AMENDMENT NO. 2 FEBRUARY 2026
IS 15169 : 2002 NEEDLES FOR SEWING MACHINES FOR INDUSTRIAL
PURPOSE — SPECIFICATION

(Page 3, clause 11.2.1) — Substitute the following for the existing:

FIG. 1 ARRANGEMENT FOR BREAKING ANGLE TEST

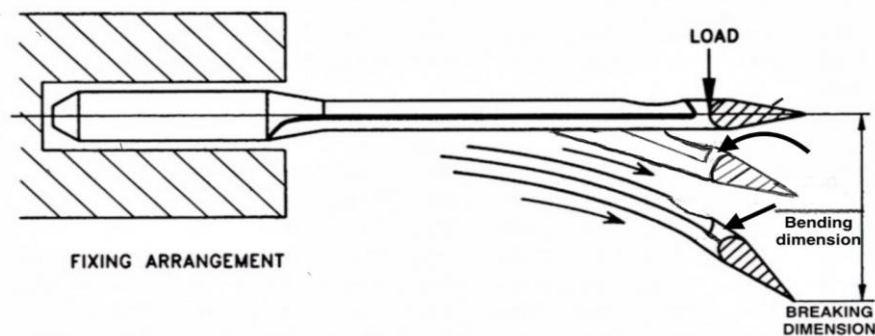
‘11.2.1 Test for Breaking Angle

The needle conforming to this standard shall withstand the breaking angle test as specified in 11.2.1.1 to 11.2.1.3.

11.2.1.1 Method of test

The needle shall be held along the full length of its shank in a suitable fixture, with the Clearance Above Eye (CAE) side facing the direction of the applied force. A gradual, uniform and continuous tangential load shall be applied near or at the eye of the needle perpendicular to the needle axis, with the long groove side under compression, as shown in the figure below.

Unlike the bending distortion test, where the force is released at a preset angle, the breaking angle test shall continue the application of force until the needle fractures.

The angle at which the needle breaks, measured from the original axis of the needle, shall be referred to as the breaking angle.

The test shall be performed on three different needles taken from the same batch. The measured breaking angle of each needle shall lie within the range of (28 ± 10) degrees.’
